**SUBJECT: QUAD CITIES NUCLEAR POWER STATION, UNITS 1 AND 2 – STAFF
ASSESSMENT OF FLOOD HAZARD INTEGRATED ASSESSMENT
(EPID NO. L-2018-JLD-0008)**

STAFF ASSESSMENT BY THE OFFICE OF NUCLEAR REACTOR REGULATION
RELATED TO THE INTEGRATED ASSESSMENT
FOR QUAD CITIES NUCLEAR POWER STATION, UNITS 1 AND 2
AS A RESULT OF THE REEVALUATED FLOODING HAZARD
NEAR-TERM TASK FORCE RECOMMENDATION 2.1 - FLOODING
EPID NO. L-2018-JLD-0008

Figure 3.2-1 Differences in Digital Elevation Model used in FLO-2D due to site changes

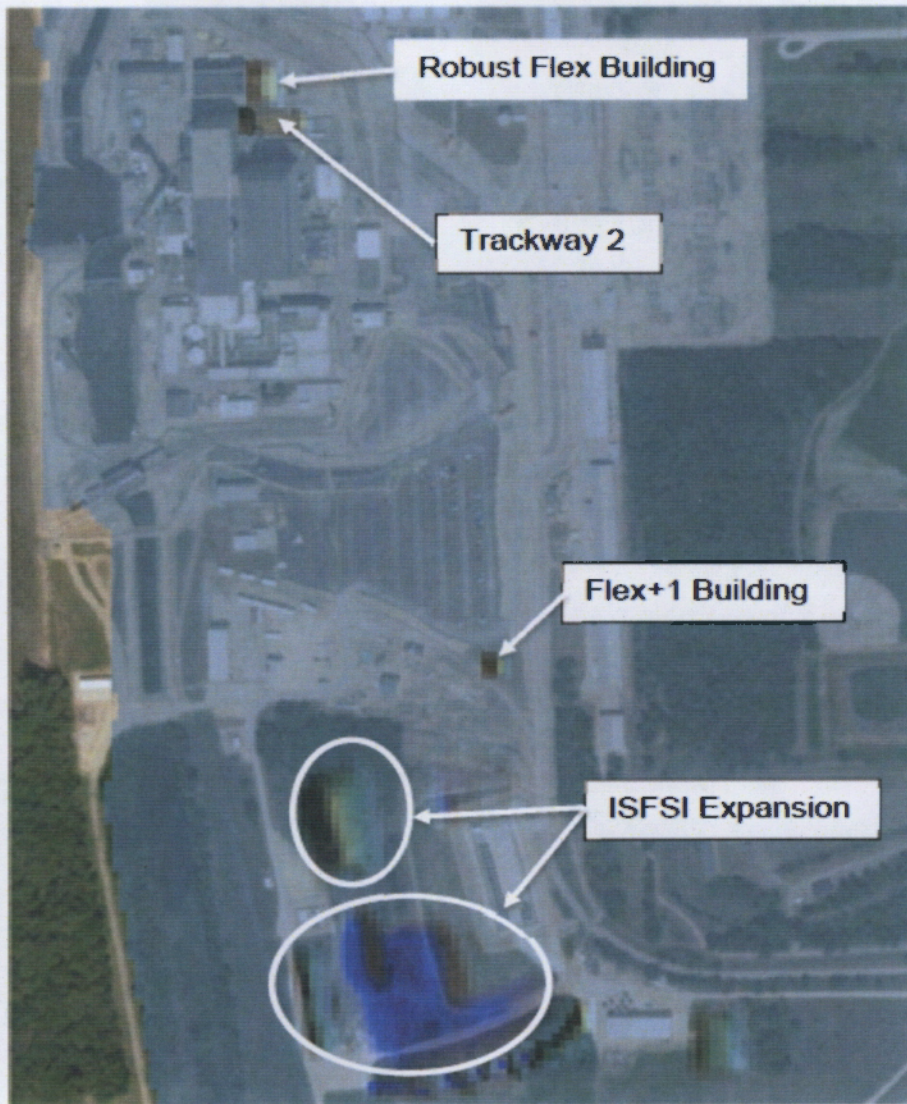
The NRC staff reviewed the changes made to the licensee's FLO-2D model by comparing the previous and current versions of the Digital Elevation Model (DEM) used in the licensee's FLO-2D model (Figure 3.2-1). The NRC staff found that changes made by the licensee to the DEM are consistent with the description provided by the licensee in their IA. Additionally, the NRC staff verified that the rooftop parapets on the RB and Turbine Building (TB) were properly incorporated into the licensee's FLO-2D model.
